# Product Change Notification

**Product Change Notification:** P-20-020033

**General Product Description:**  
The UL Approvals change for 2213800 series of Coolsplice

DWN	12NOV2020	MATERIAL	-	HEAT TREAT	-
CHK	12NOV2020				
APVD	12NOV2020				
NAME N.S.COOLSPLICE					
SCALE	2:1	SIZE	A3	DRAWING NO	2213800
SHEET 1 OF 2		REV C

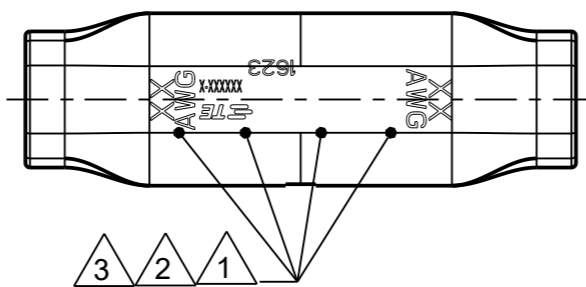
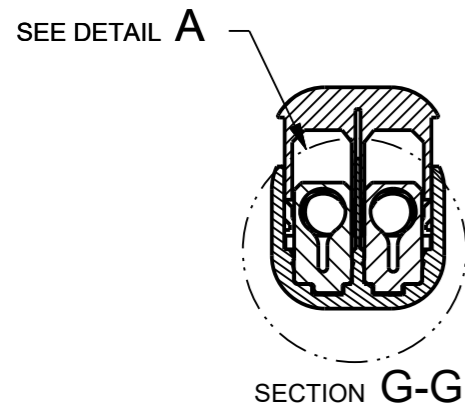
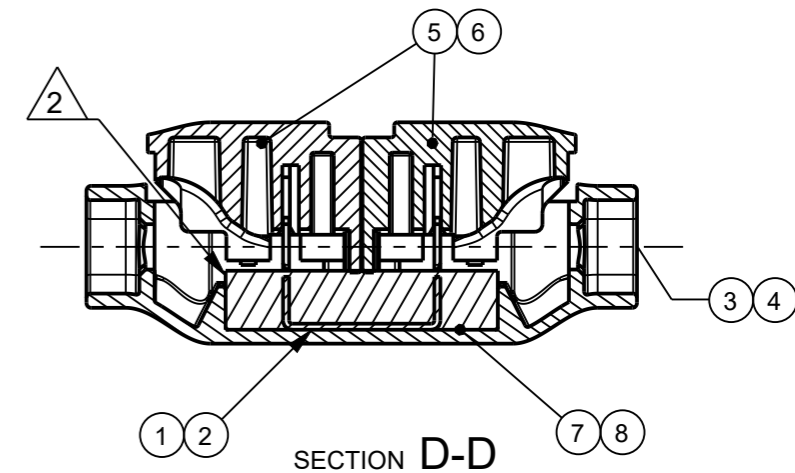
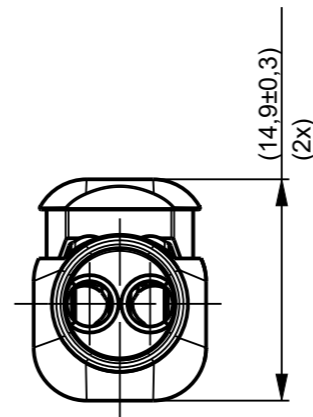
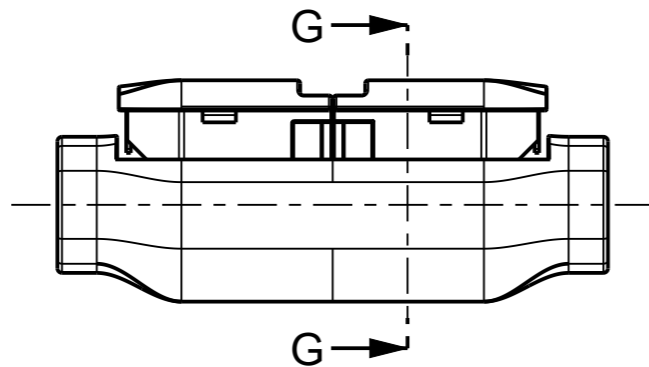
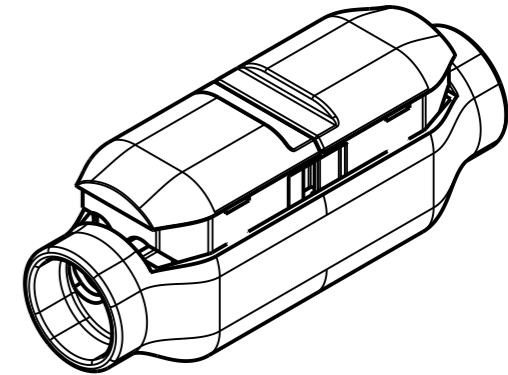
**Description of Changes**  
The UL Approvals for the 2213800 series of Coolsplice products will be changing from UL listing per UL2459 to UL Recognition per UL1977. This represents a change in form (Product Markings) and function (change from UL Listed Component to UL Recognized Component). Please review the impact of this change for your application.

**Reason for Changes:**  
New specification."As in form fit change, only marking on the product will be changed accordingly: NEW PRINTING LOGO'S: cURus Logo, KEMA, PARTNUMBER, TE, DATE CODE, WIRE SIZE, IP CLASS."

LOC	C	U/D Logo UL Listed to cURus	12NOV2020	VR	VY
H	B1	ECR-17-015691	25OCT2017	RK	PO
DIST	B	ECR-17-008373	16OCT2017	RK	PO
-	P	LTR	REVISION RECORD	DATE	DWN APVD

PRINTING LOGO'S: cURus Logo, KEMA, PARTNUMBER, TE, DATE CODE, WIRE SIZE, IP CLASS.
